Final Environmental Statement related to the operation of Nine Mile Point Nuclear Station, Unit No. 2

Docket No. 50-410

U.S. Nuclear Regulatory Commission

May 1985

Figure 4.1 Site layout
Source: ER-OL Figure 3.1-1

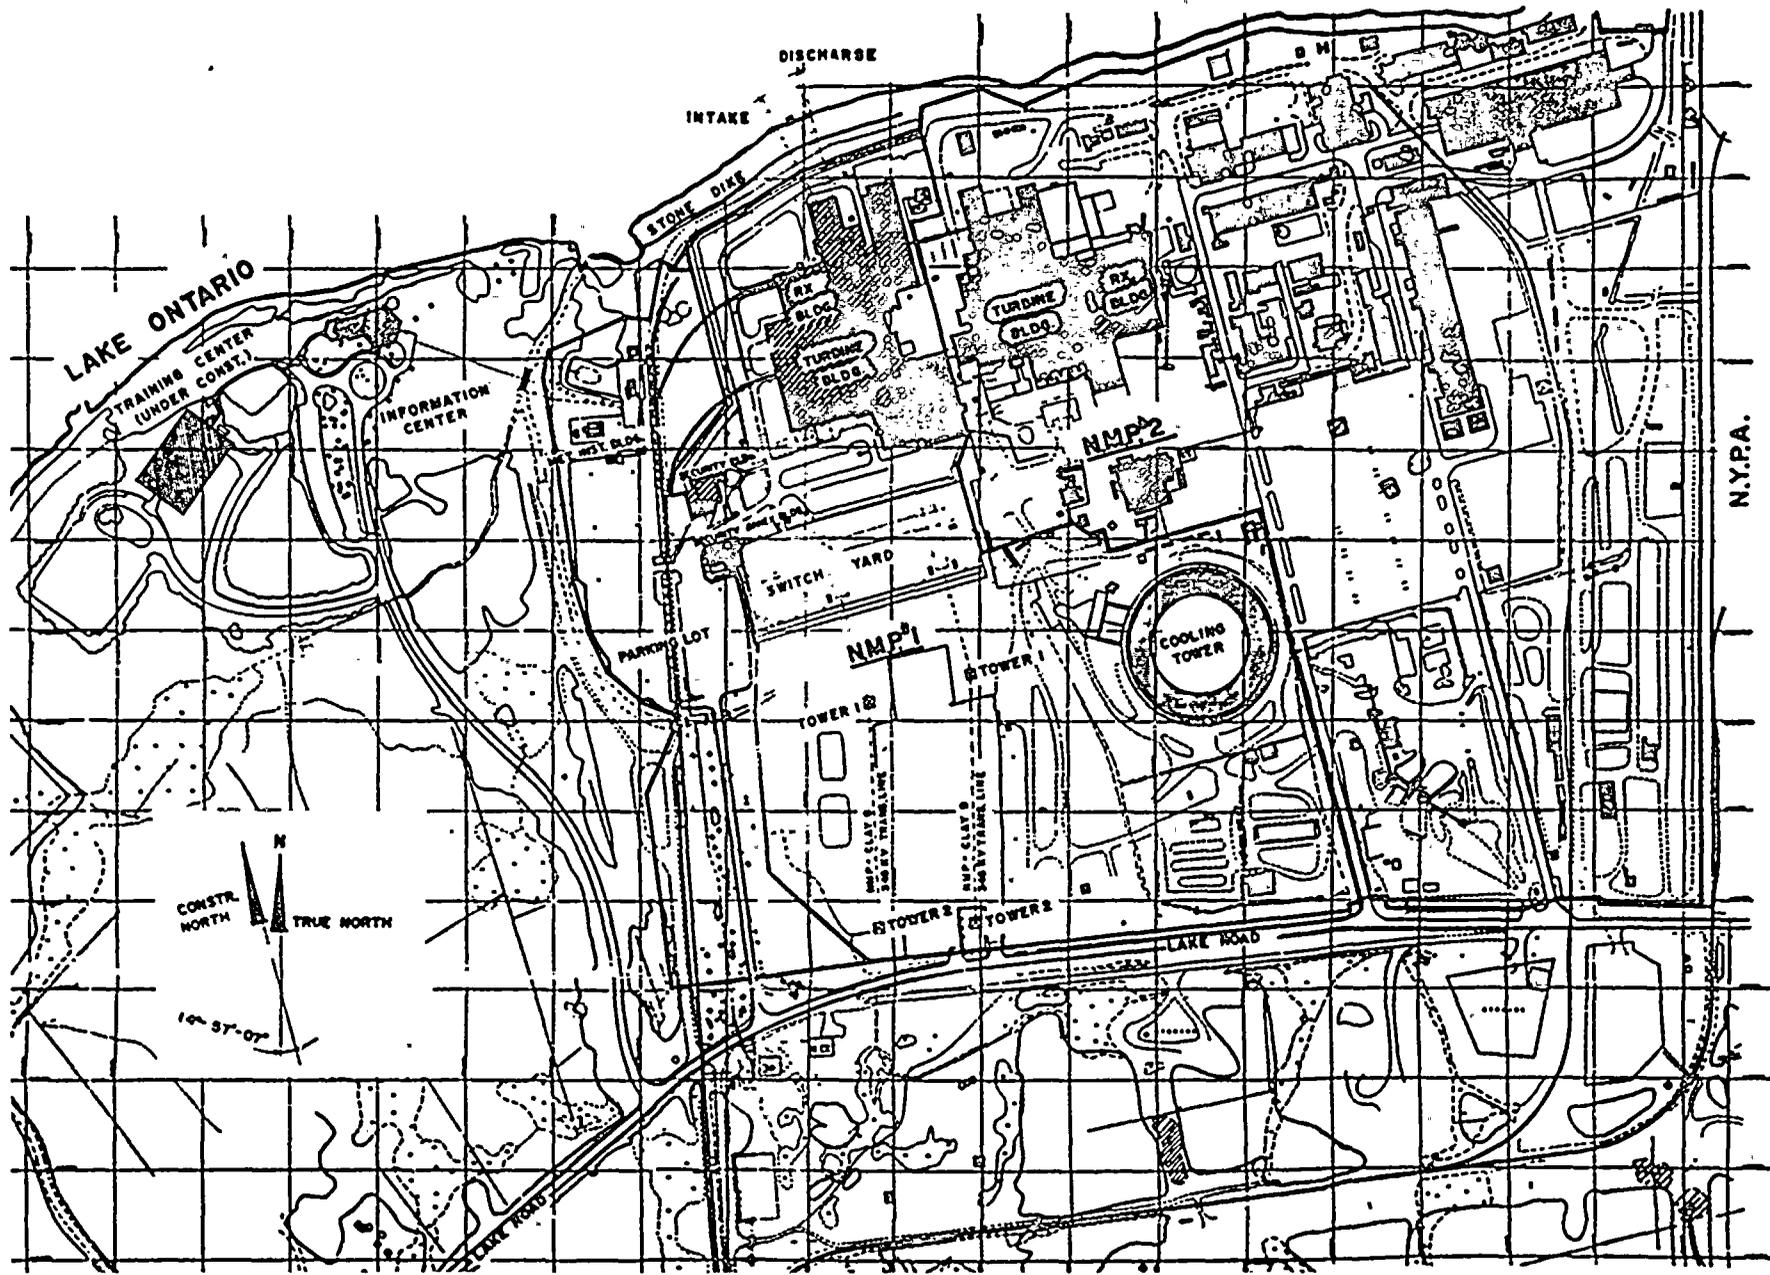
19. Section 4.3.1.1 (Page 4-8) and Section 5.3.3.1 (Page 5-4) should be clarified to indicate that the east and west berms, Lake Road berm and the southeast berm were constructed, as shown on Figure 4.1, to protect the Unit 1 and Unit 2 plant complex from flooding. NMPC-19

Figure 5.13 Estimated early fatality risk with supportive medical treatment (persons) from severe reactor accidents for several nuclear power plants either operating or receiving consideration for issuance of a license to operate. See footnotes following Figure 5.21.

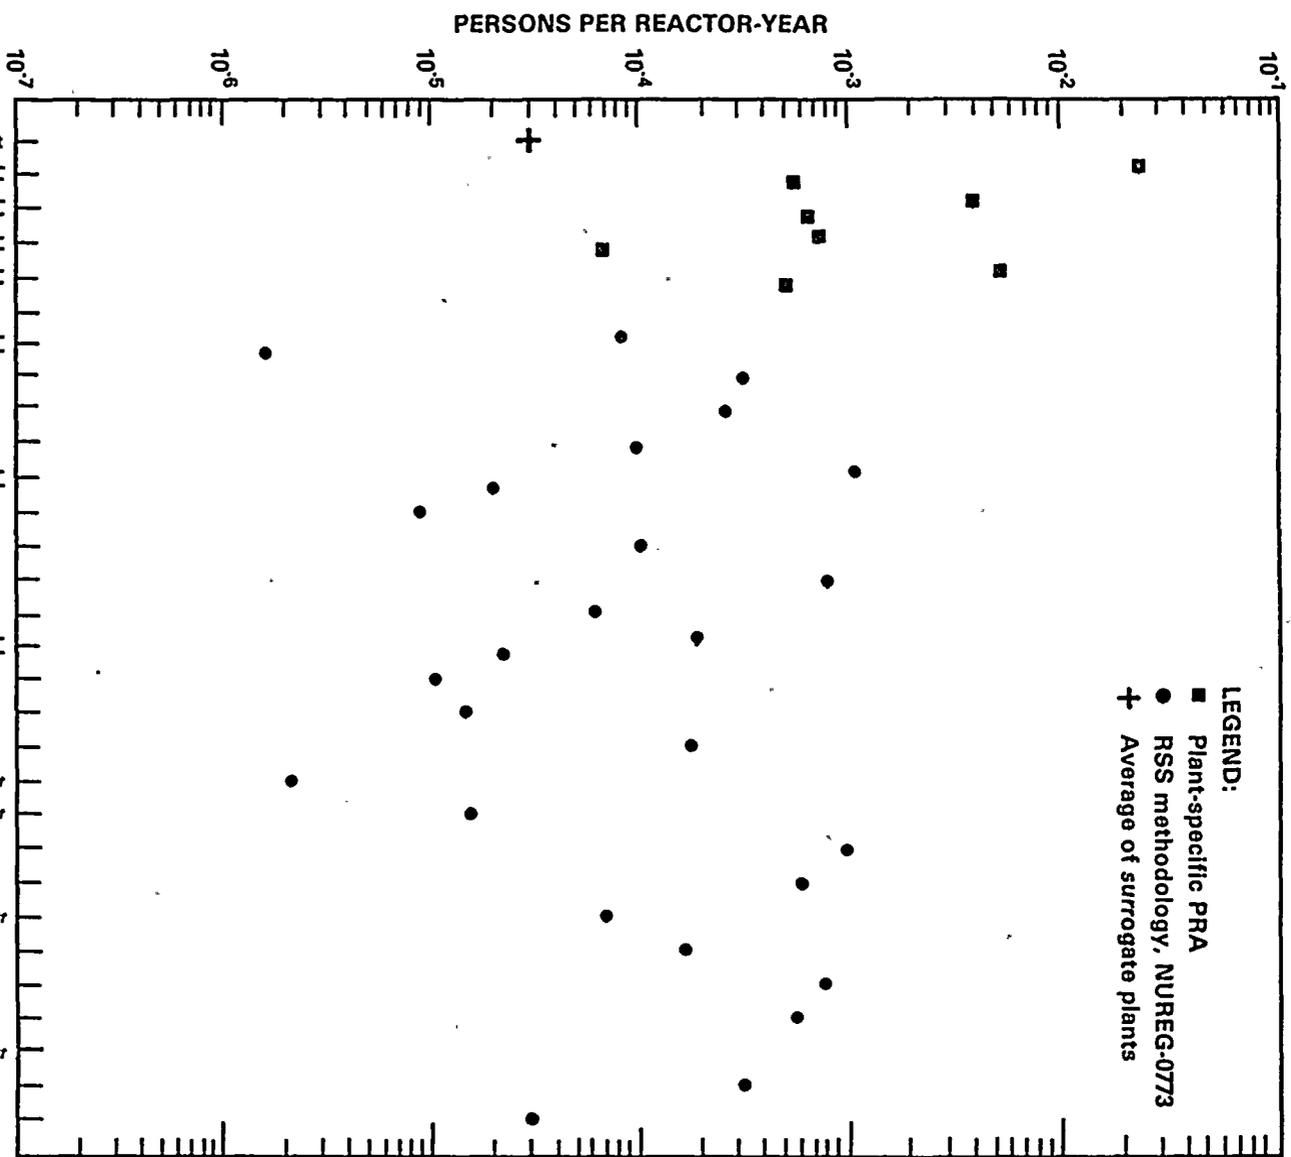
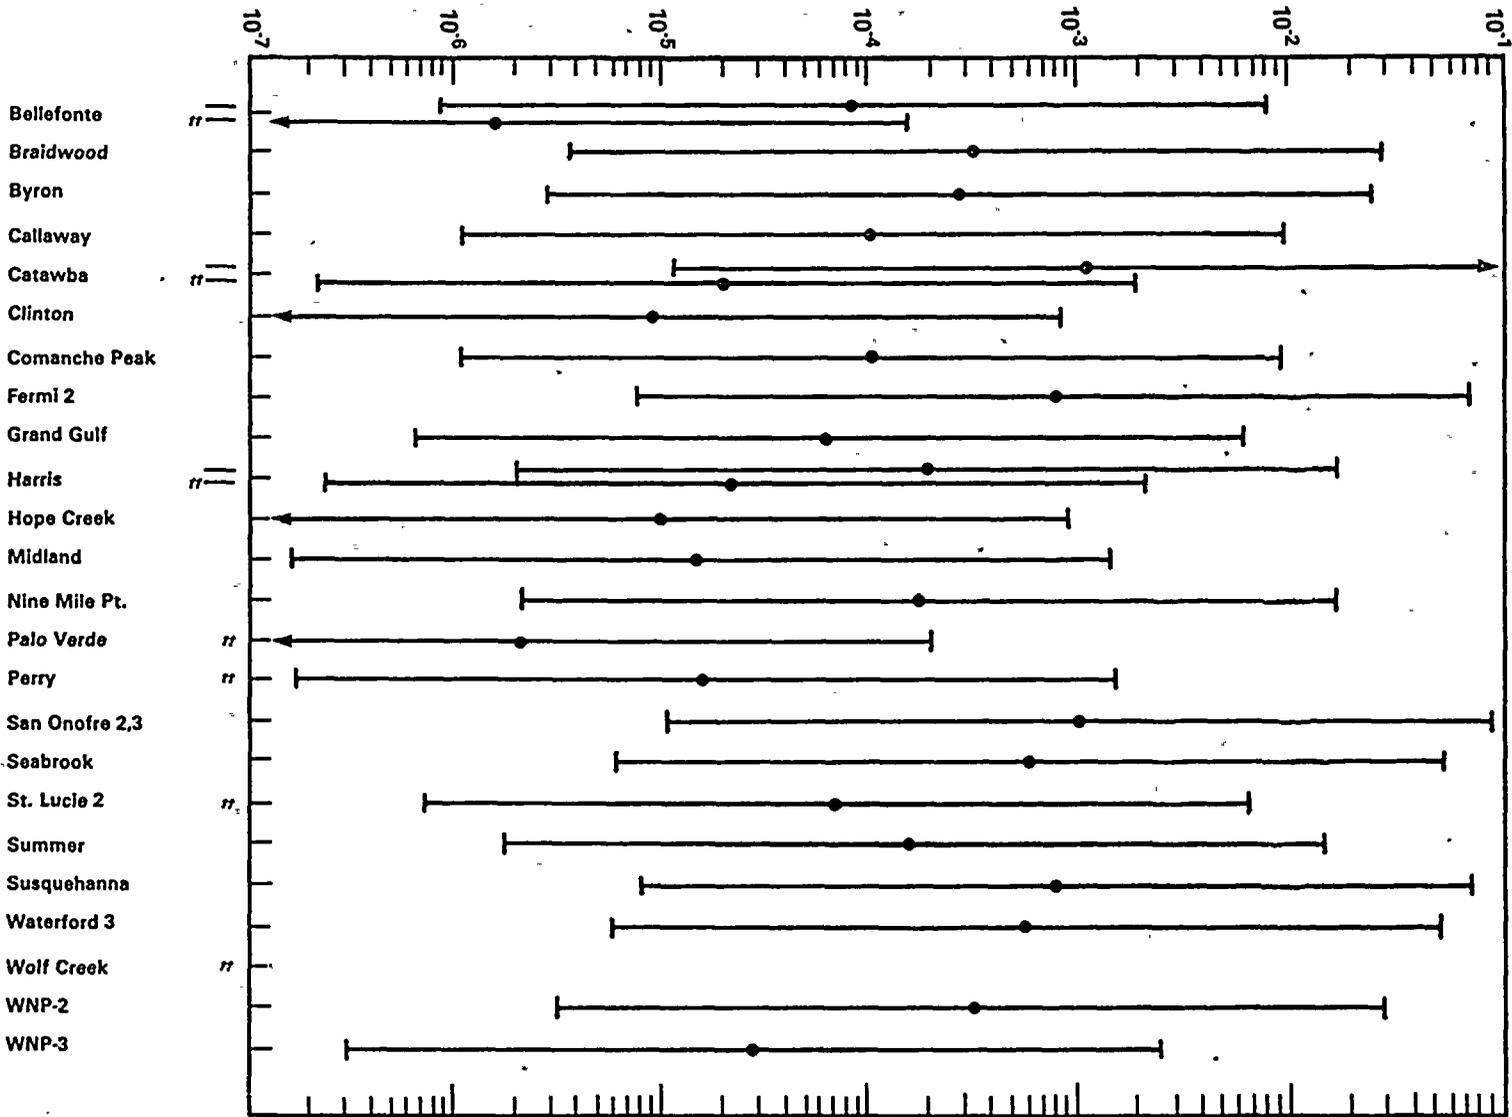
16. On Figures 5.13 and 5.15, arrows on the X-axis are pointing to the Wolf Creek plant rather than Nine Mile 2. NMPC-16
17. On Page 4-13, Paragraph 3, line 1, it is indicated that winds are measured at the site at the 10 meter and 61 meter levels. Winds at the site are also measured at the 30 meter level. NMPC-17
